**SECTION 00 91 13.01**  
**ADDENDA #01**

- A. Project Name: Royal C. Johnson Veterans Memorial Medical Center New Front Lobby & Primary Care Addition.
- B. Owner: U.S. Department of Veterans Affairs.
- C. Owner Project Number: 438-480
- D. Architect: Stone Group Architects.
- E. Architect Project Number: 201909.
- F. Date of Addendum: February 13, 2024.

Drawing Number  
**EE101**

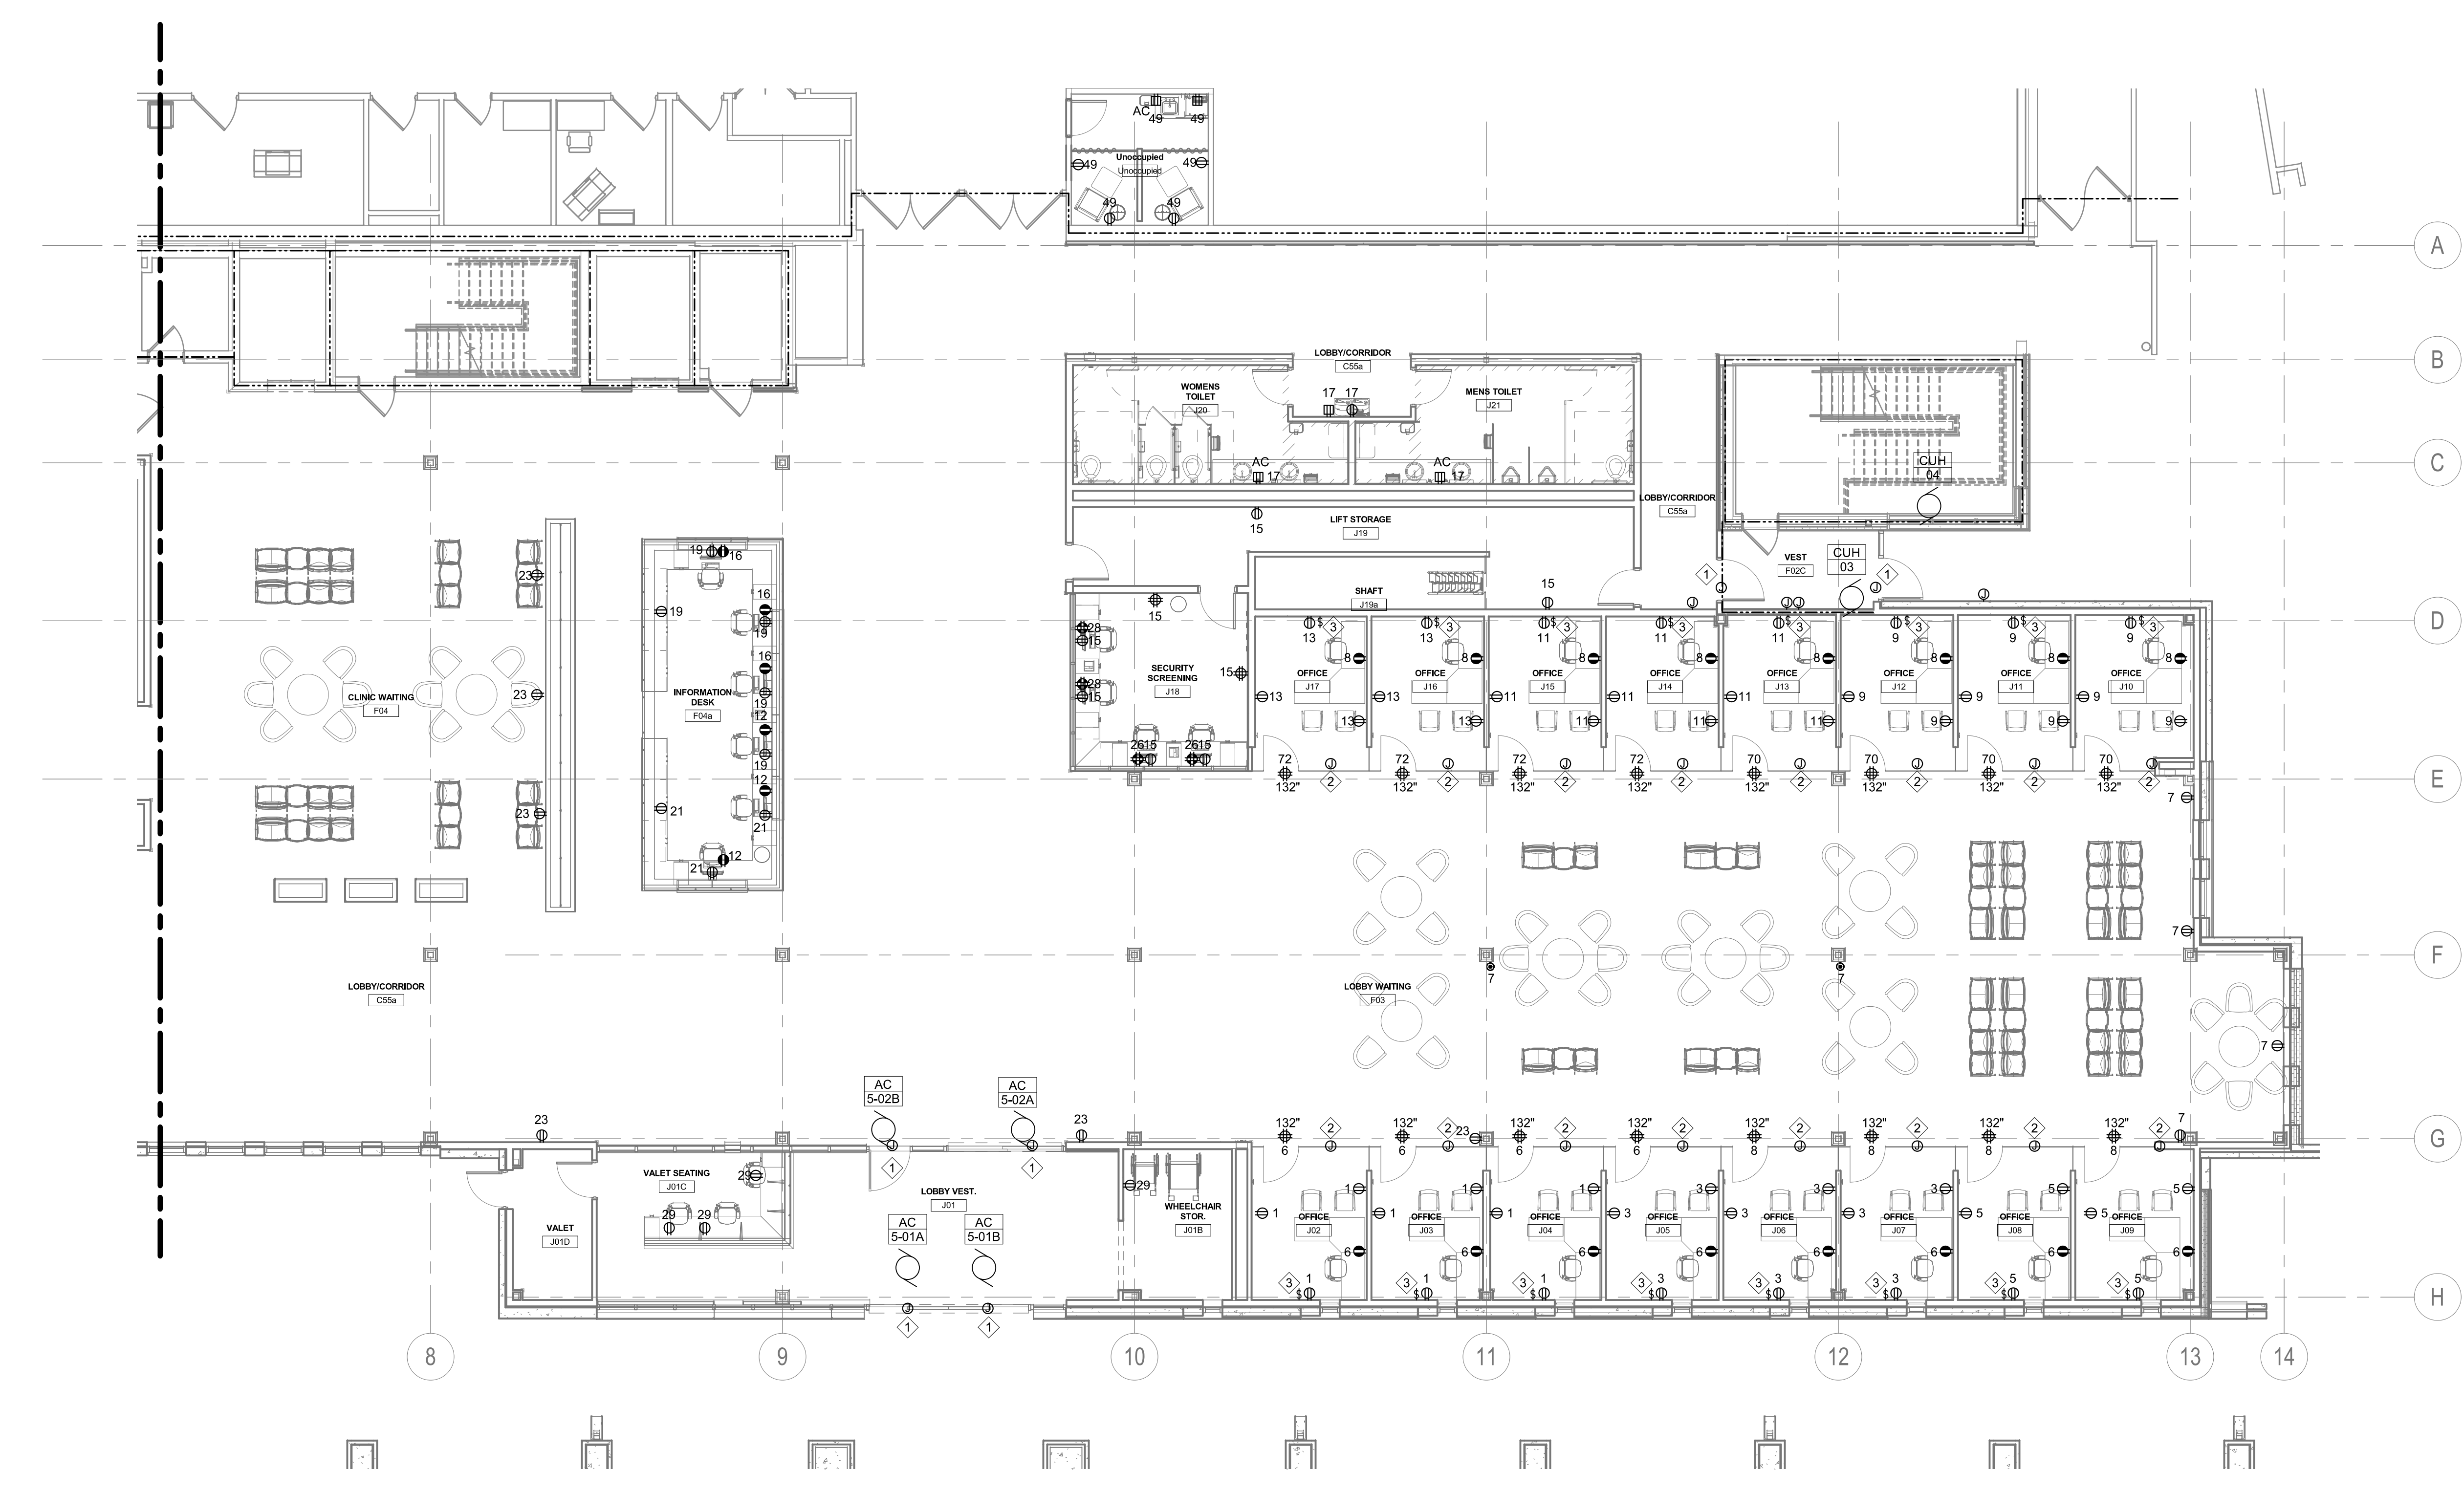
- AA. Sheet EE101 - ELECTRICAL SITE MEDIUM VOLTAGE PLAN (reissued).
1. Revise Medium Voltage Feeder to Transformer 38.
- BB. Sheet EP102 - GROUND LEVEL POWER PLAN AREA B (reissued).

**Drawing Number**  
EE302

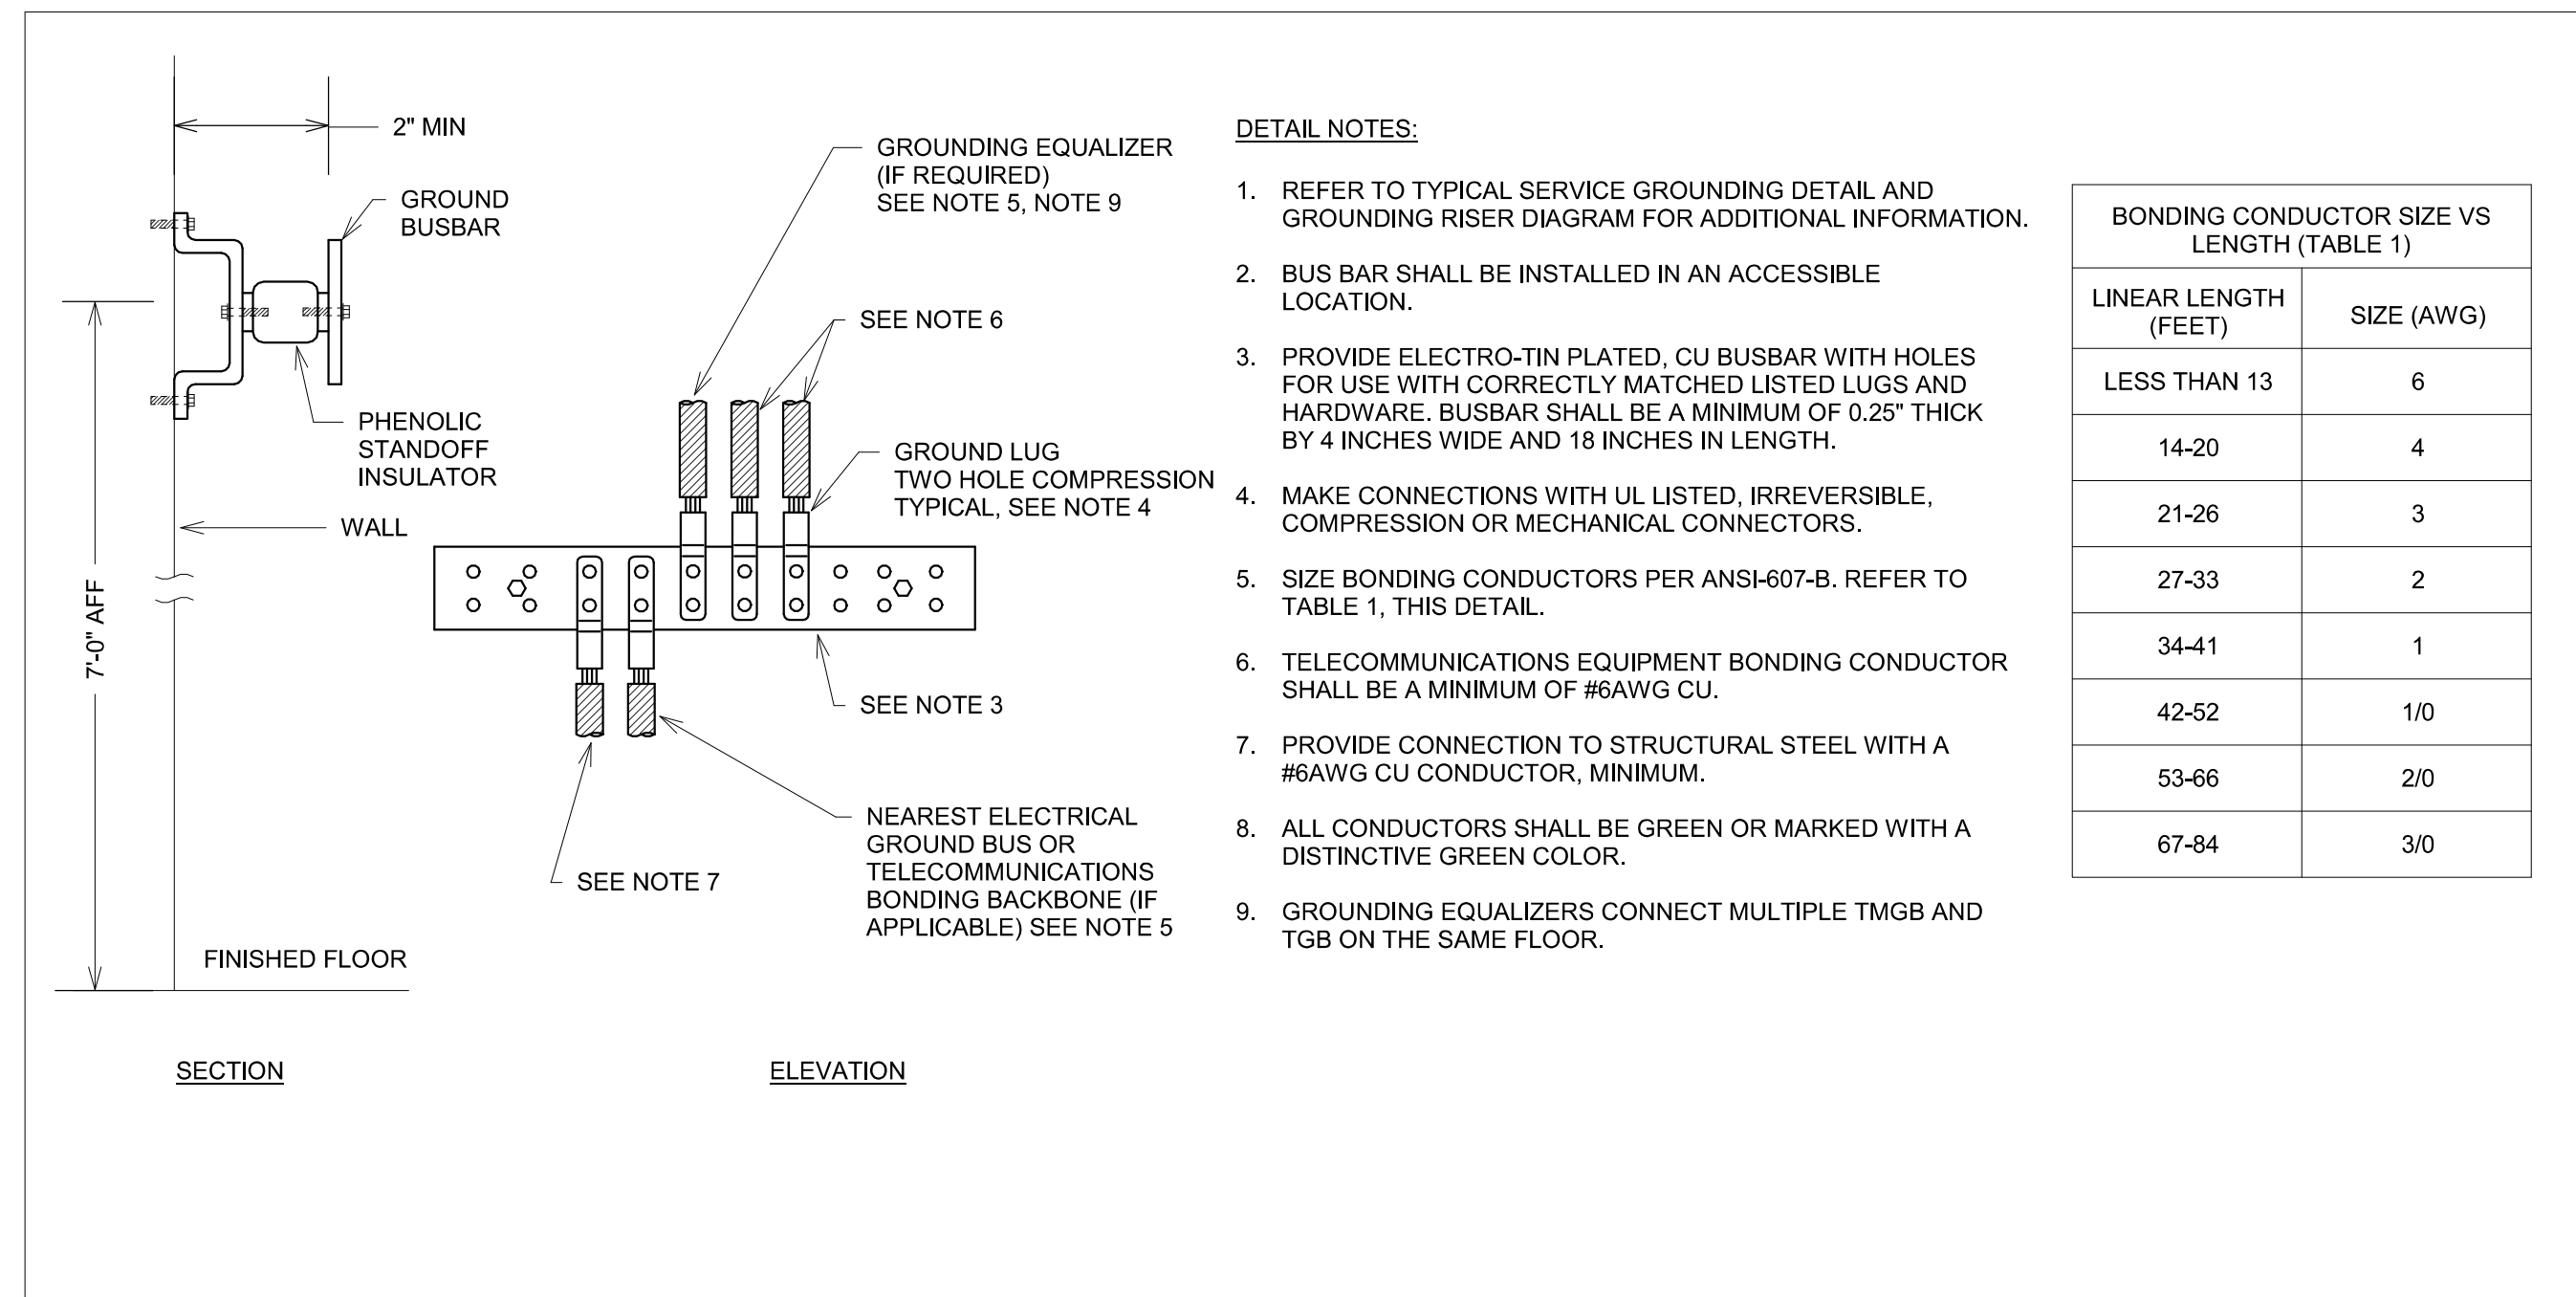
1. Revise Medium Voltage Cabling.
- EE. Sheet EE501 - ELECTRICAL DETAILS (reissued).
1. Detail 7 - Revise Keynotes 4 and 5
- FF. Sheet EE503 - ELECTRICAL DETAILS (reissued).

6 BOLLARD BASE DETAIL  
NOT TO SCALE

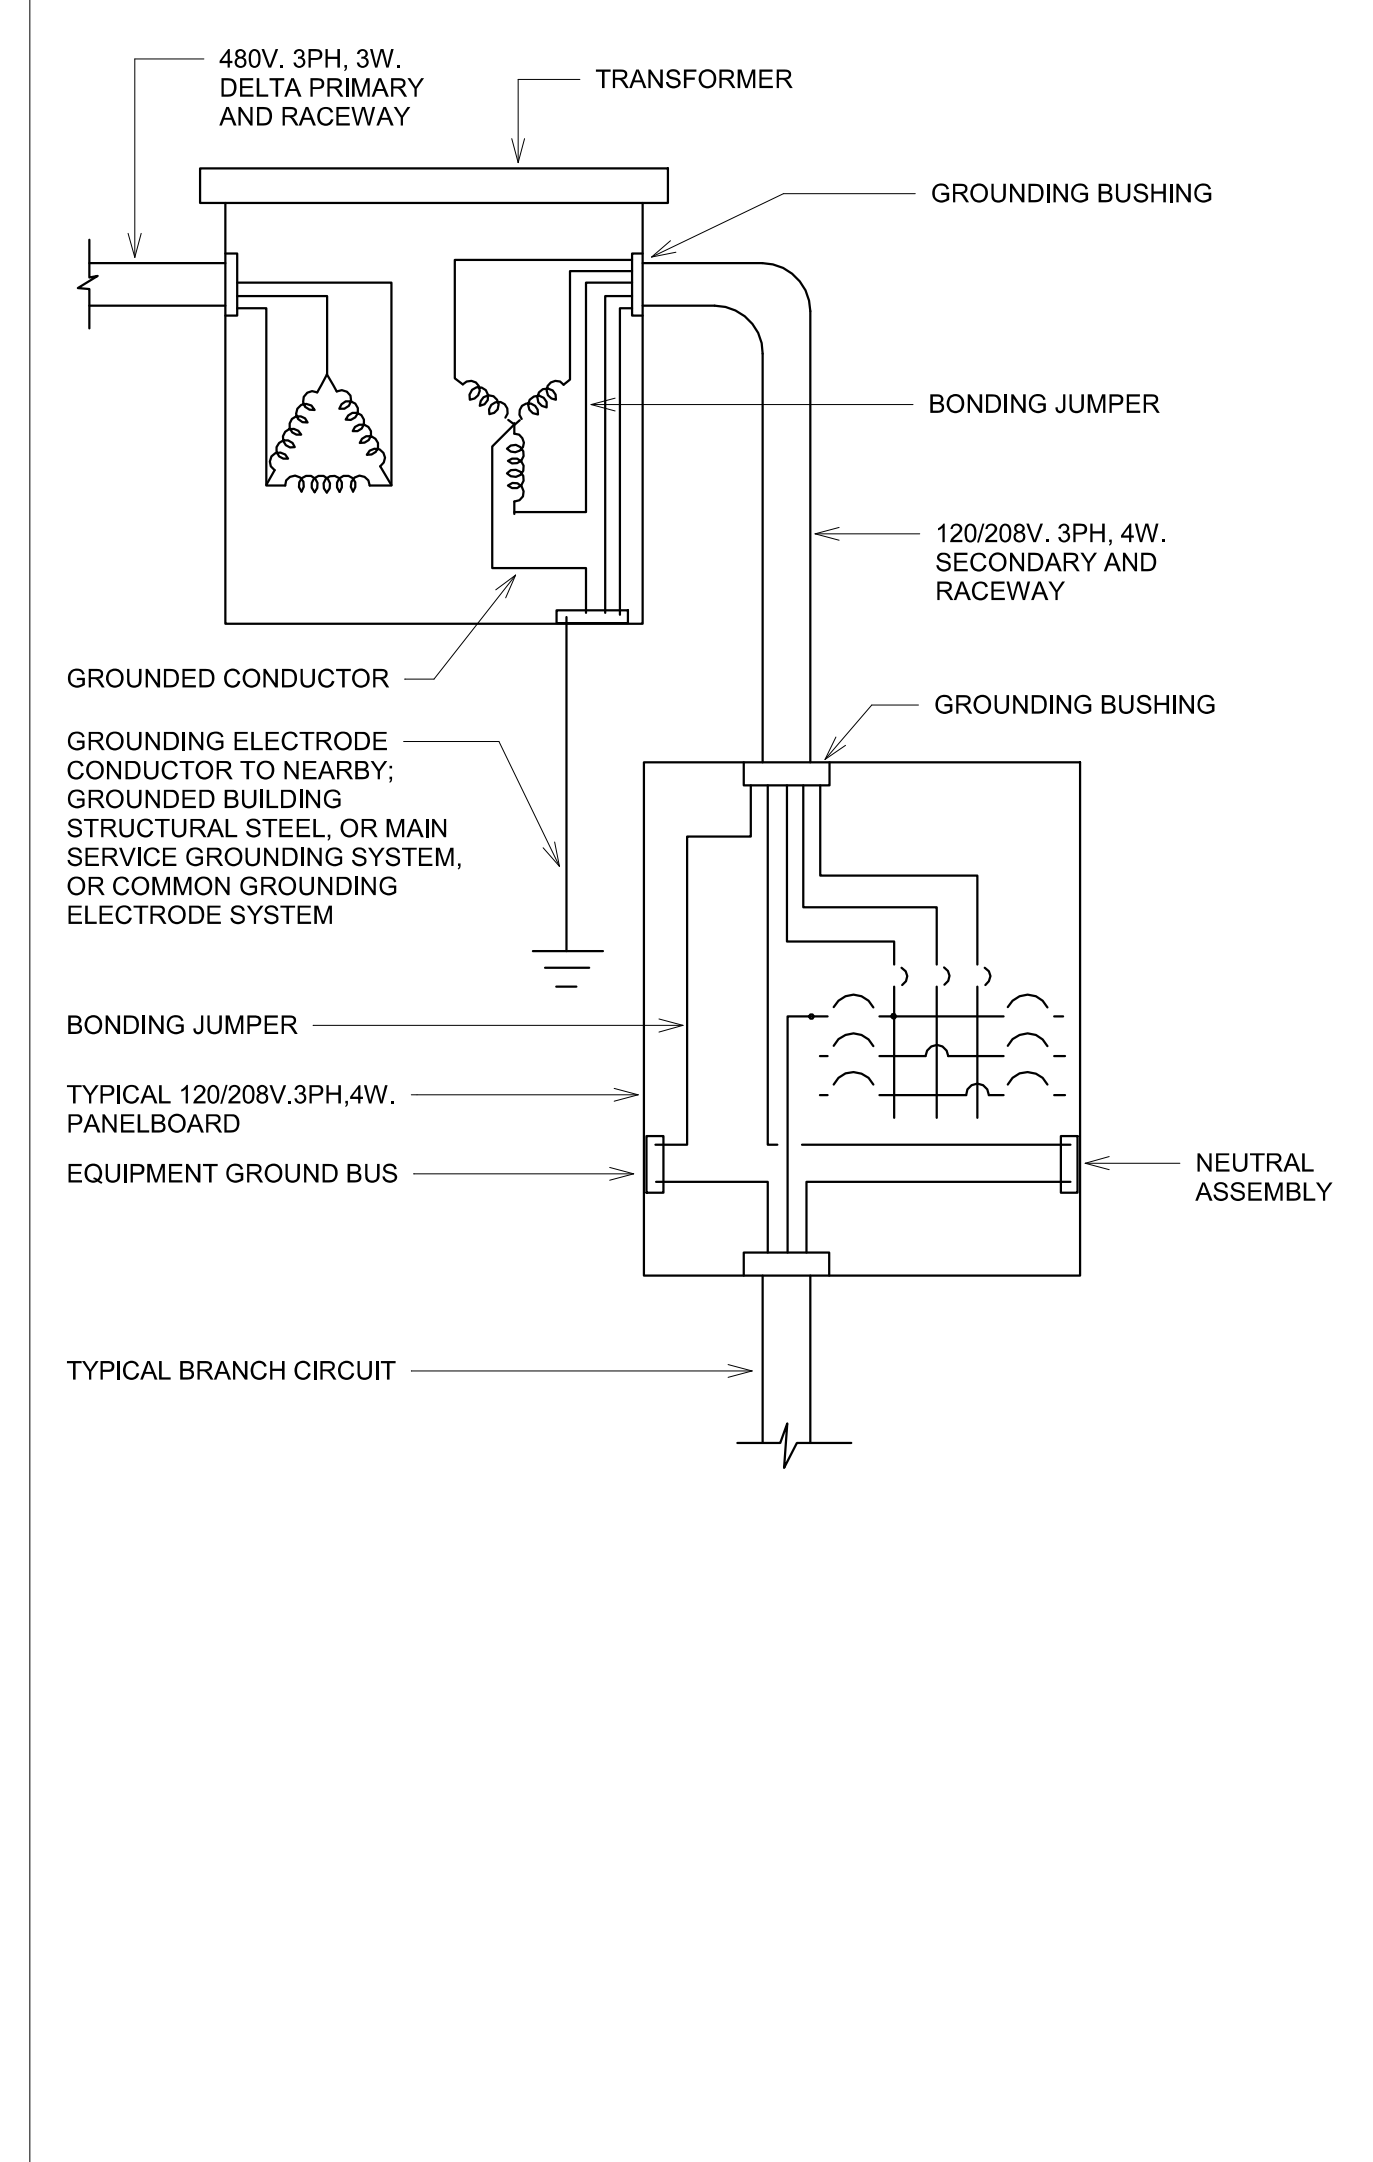
1. Detail 6 - Add new detail Bollard Base Detail
